Access Compliance Report

Public Rights-of-Way

(Curb Ramps)

Intersection ID: 17665	Main Street: MENDENHALL_CT	Cross Street: TANGLE_DR	Location:	N
ADA ID: 5B5596BCCE08	Ramp Type: BlendTrans1	Initial Pass/Fail: Fail	Overall Compliance: No	Severity Score: 1.25

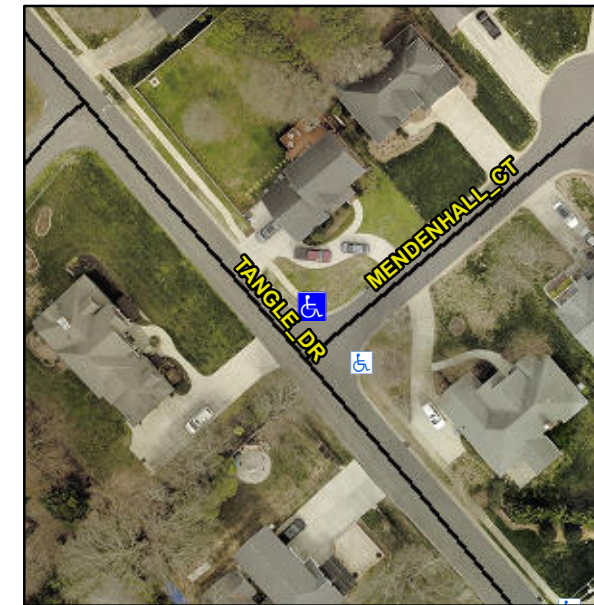
Not Found, R304.5.3

Remove & Replace Curb Ramp With Two New Directional Ramps or Equivalent.
